TO: Scott Cosman, P.Eng.
COMPANY: BC MOTI
FROM: Bob Forsyth
DATE: June 26, 2023
CC: Binnie: Zach Crippen, PMP.
PROJECT NO.: VG07796.A04
SUBJECT: Edwards Road, Chilliwack, BC
Flood Recovery Project –Site C Conceptual design of Retaining Wall
Project Number: 14095

1.1 CONCEPTUAL DESIGN PROVIDED IN OUR FEB 23, 2023 MEMO

1.2 COMMENTS ON PRELIMINARY WALL DESIGN

Figure 1: Plan View of Site C

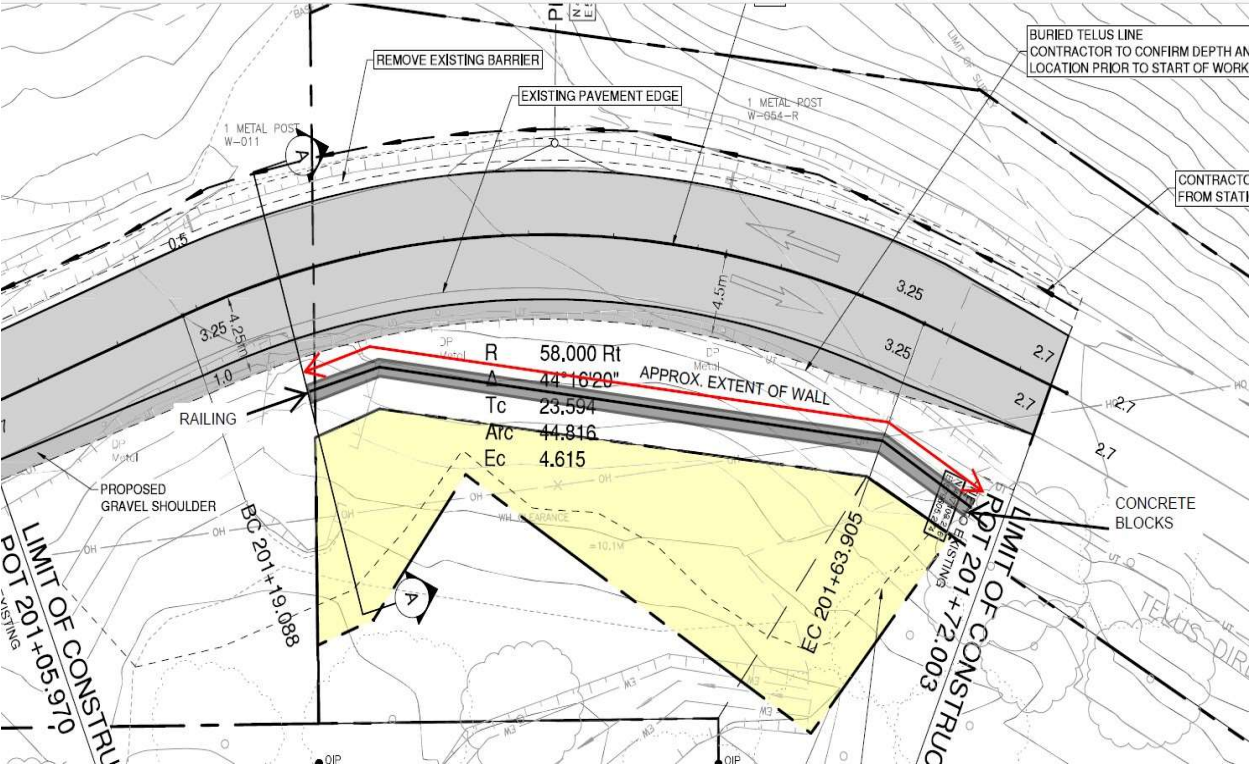
An alternative to the buttress fill would be to construct a retaining wall entirely on the Edwards Road Right of Way. The conceptual location of the wall is shown in plan on Figure 1. A typical wall section is shown in the inset drawing in Figure 1 and in more detail in Figure 2. The wall design could be as follows:

- We envisage that the wall would be up to about 3 m high and could be an MSE (Mechanically Stabilized Earth) wall constructed with a concrete block facing and reinforced backfill. The wall shown is constructed with a facing of interlocking 1500 X 750 X 750 mm concrete blocks. Many other types of wall facing are possible and are included in BC MOTI's Recognized Products List.
- The lower block is typically fully embedded in the ground.

- The backfill of the wall is reinforced with geogrid. A uniaxial geogrid with a minimum ultimate tensile strength of 70 kN/m is recommended.
- The reinforcement should extend a distance, H, equal to the wall height, back from the wall outer face.

Figure 2: Typical MSE Retaining Wall Section

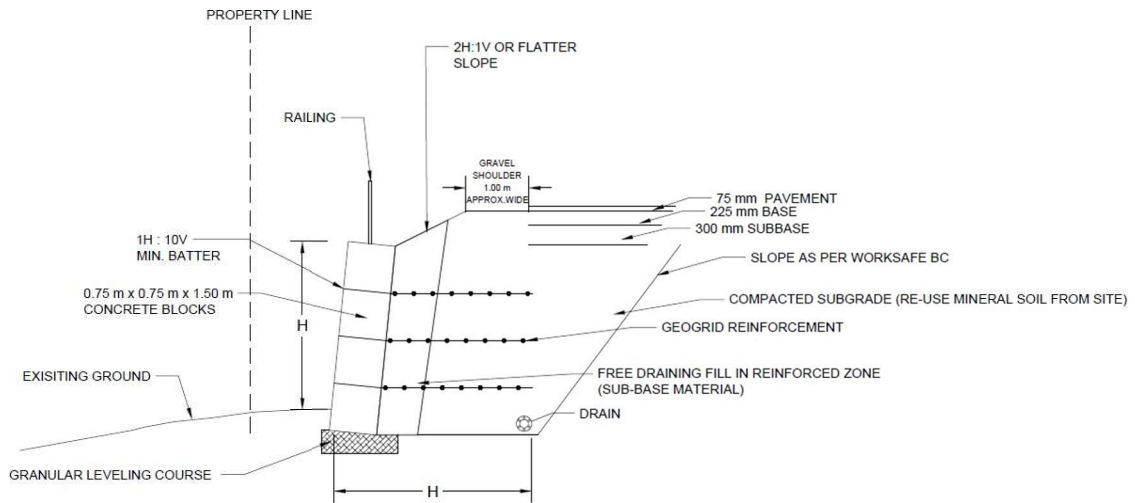
- 1** The wall is 3 m high, as per our conceptual section, in its western 11 m. Further to the east the wall height decreases to 1.5 to 2.25 m.
- 2** Drainage of the wall backfill is very important. The drain should consist of 150 mm diameter perforated PVC pipe covered with about 150 mm of drain rock all wrapped in non woven geotextile. The drain outlet should be toward the relatively flat ground at the west end of the wall.

- 3** The lower block should be embedded in the ground and based on stiff/dense native mineral soil. All existing fill and/or organic material should be removed from beneath the lower block and replaced with engineered fill material, typically consisting of road subbase or base. If deemed appropriate by the geotechnical engineer, the replacement fill could be reinforced with geogrid for additional strength.

- 4** The reinforced zone of wall backfill should extend back from the wall face a distance equal to the wall height. (ie: for a 3 m high wall, the geogrid should extend back a distance of 3 m from the face. The width of reinforcement can be decreased with decreased wall height).

- 6** Our analysis of the 3 m high wall section indicate that the static and seismic factors of safety of global slope stability for the wall exceeds 2.0. In this case the wall backfill is drained and the wall is based on stiff or dense native soil or engineered fill placed on top of such.
